RE: Groundwater Assessment Monitoring Plan
Francis Farm Landfill, Permit Number 44-03
Haywood County, North Carolina

**Subject: Proposed Well Locations and Depths for the
Groundwater Assessment Monitoring Plan
Closed Francis Farm Landfill**
Haywood County, North Carolina
BLE Project Number J09-1957-11
Permit Number 44-03

Proposed Well Locations & Depths for the Groundwater Assessment Plan
Francis Farm Landfill - Haywood County, North Carolina

ESTIMATED GROUNDWATER ELEVATION MAP ON AUGUST 24, 2009 WITH PROPOSED MONITORING WELL LOCATIONS
 BLE ASSESSMENT PLAN - DECEMBER 2009
 CLOSED FRANCIS FARM LANDFILL
 HAYWOOD COUNTY, NORTH CAROLINA

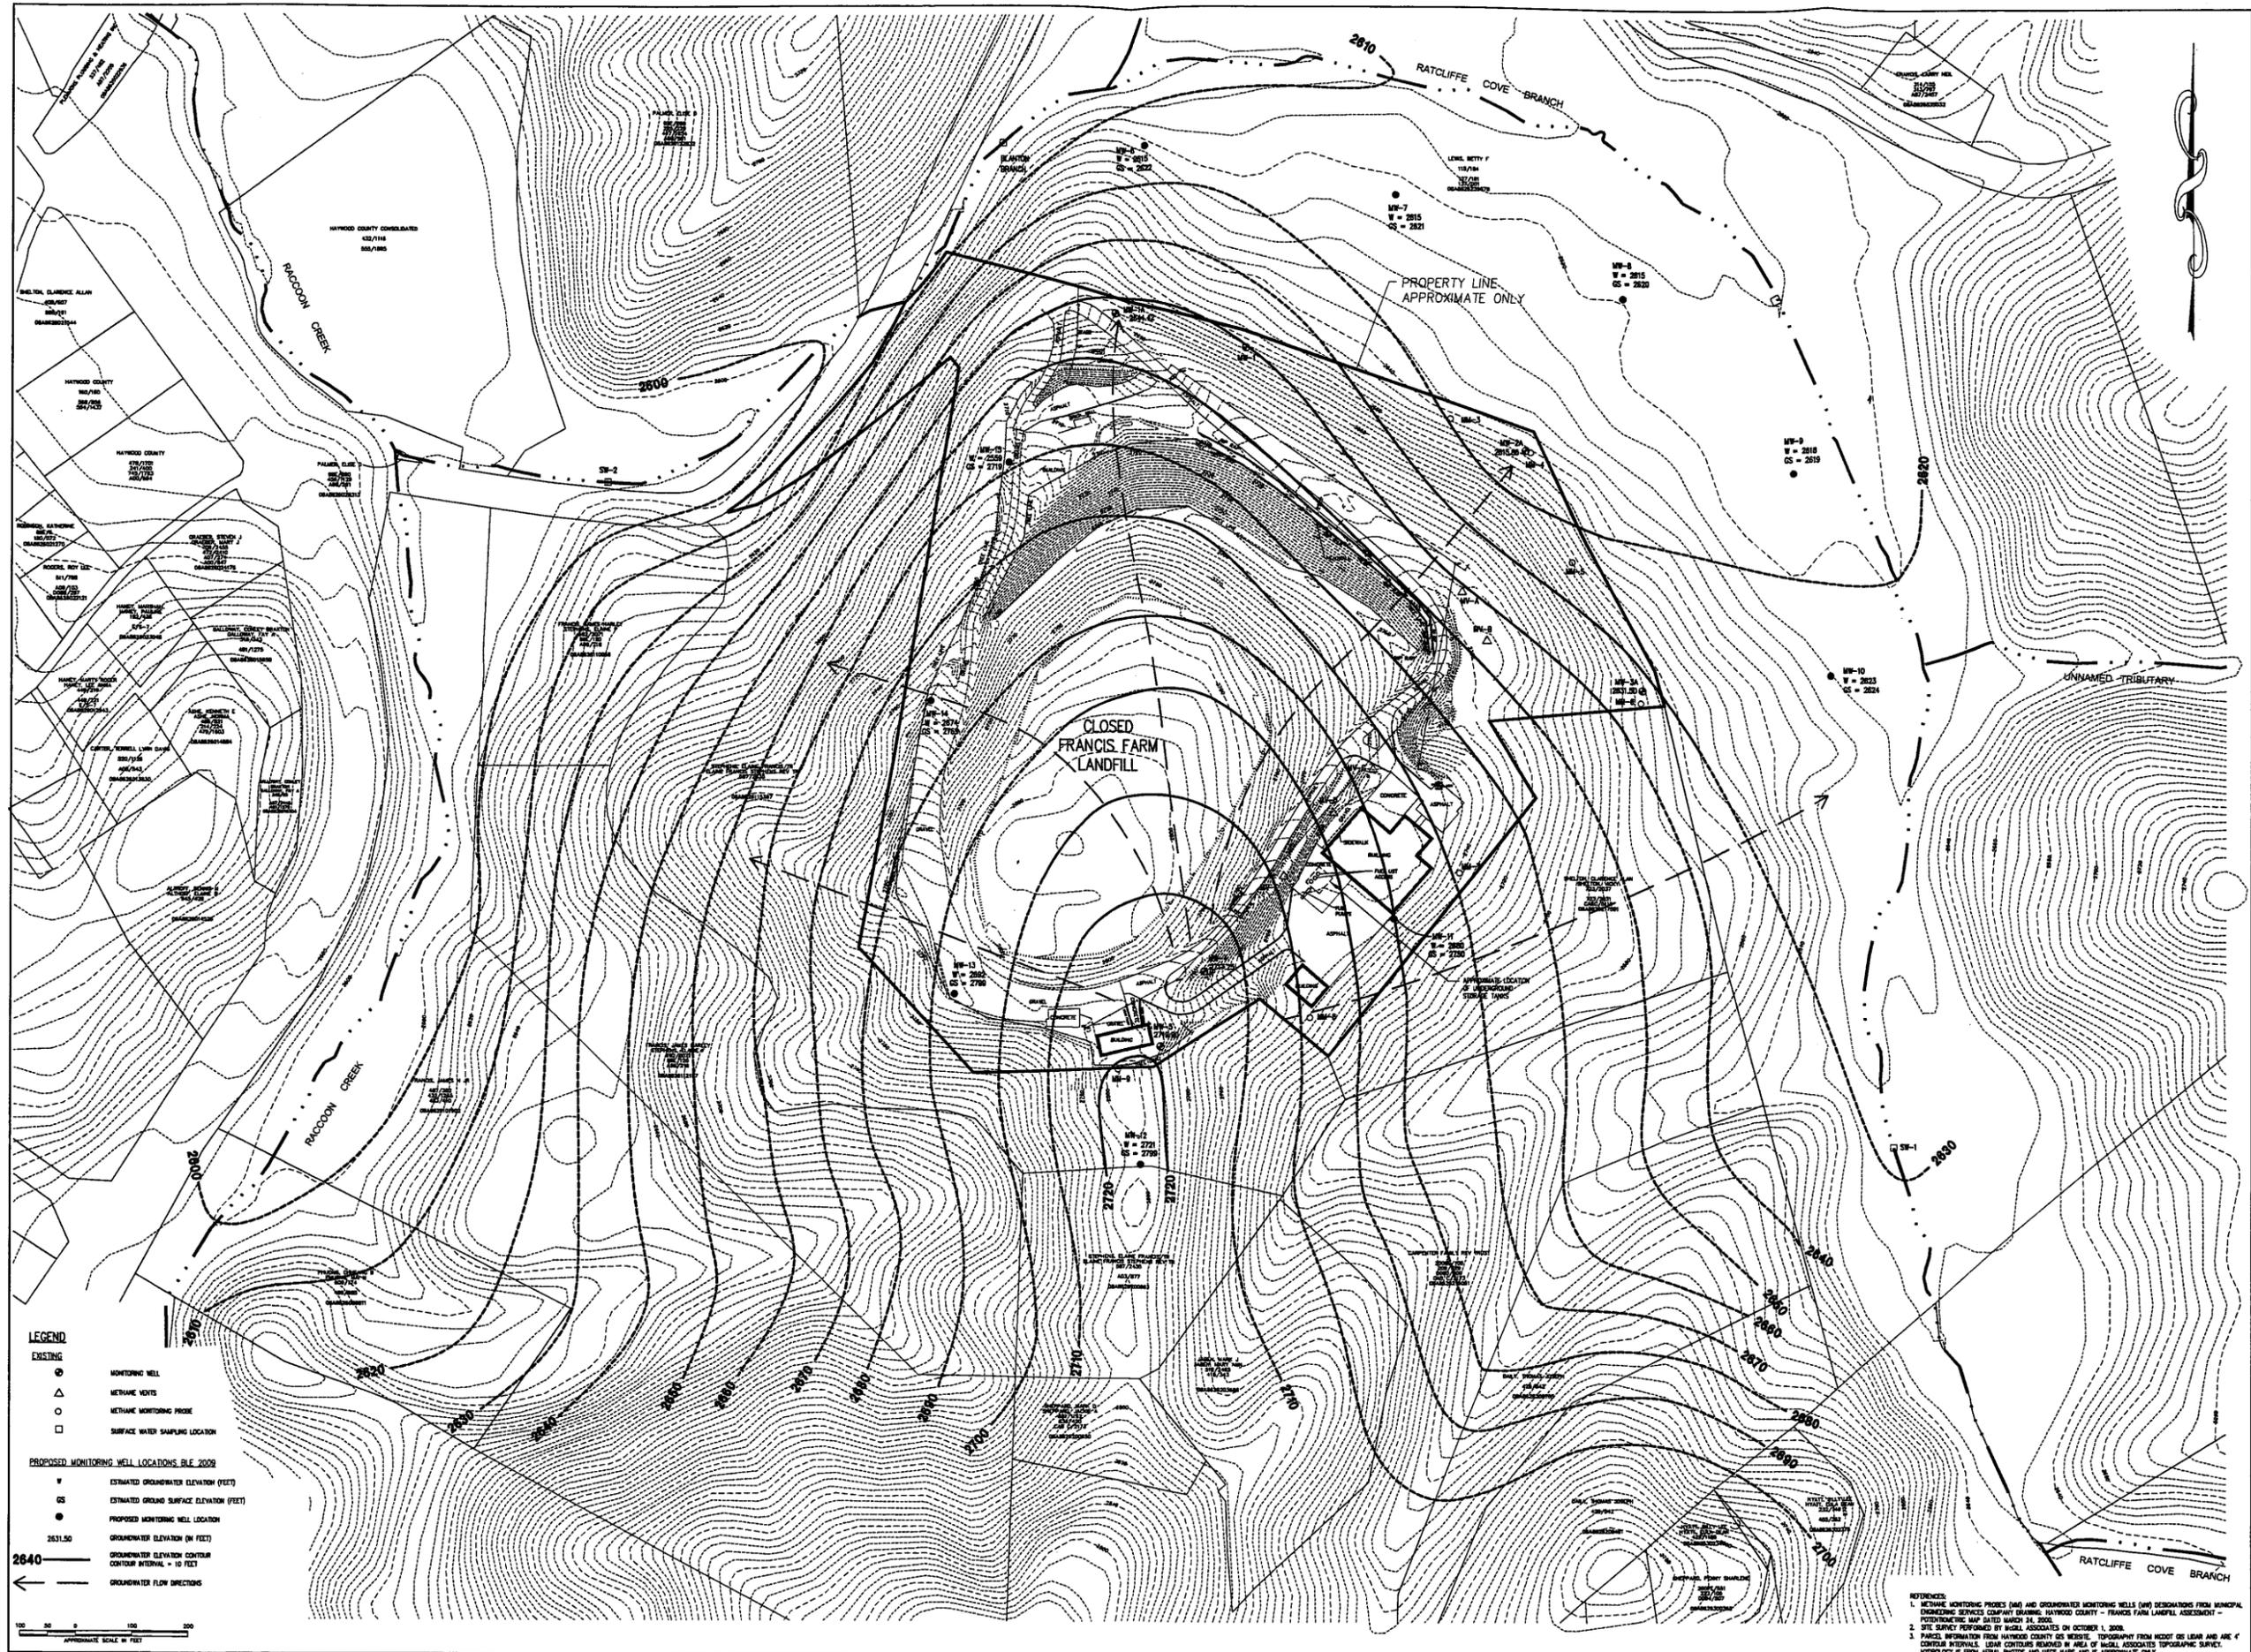
As described in our letter we have prepared the attached map and table by merging the on-site and off-site survey/GIS data from multiple sources. It now appears that the groundwater flow at the site is radial with the center of the radius near the monitoring well MW-5 location (Figure 1).

Based on our analysis, we have relocated several of the proposed on- and off-site well locations and eliminated some of the proposed wells. The proposed groundwater monitoring wells are now designated MW-6 through MW-15 (Figure 1). As requested by the NCDENR, we have prepared a table of proposed well depths (Table 1) as part of this submittal. Please note that these data are approximate, actual depths will be determined in the field based on the occurrence of groundwater. Actual well locations may be changed based on factors such as drill rig accessibility, etc.
